# UNITED STATES PATENT AND TRADEMARK OFFICE

### Office Action Summary

10/523,752

## **DETAILED ACTION**

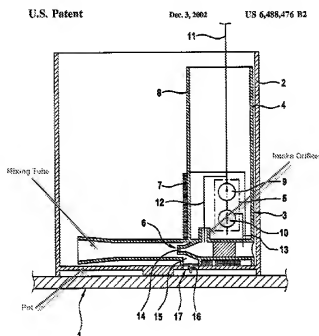
In regards to claim 1, Eck discloses a suction jet pump (6) comprising of a propulsion jet nozzle (14), which can be interpreted from Fig. 1 as structurally consisting of a round nozzle orifice as claimed. Eck discloses further a mixing tube; an intake orifice and a suction line (12) arranged thereon, wherein at least part of the mixing tube is arranged in a pot, assigned to a baffle (2) (see Fig. 1 labeled by examiner for clarity).

With respect to claim 2, the illustration of Fig.1 according to Eck discloses the outlet orifice of the mixing tube is arranged inside the pot (see Fig. 1 labeled by examiner for clarity).

In regards to claims 6 and 10, it can be seen in Fig. 1 according to Eck that the pot is connected to the suction jet pump (6). Furthermore, Fig. 1 illustrated that the pot is formed on a baffle (2).
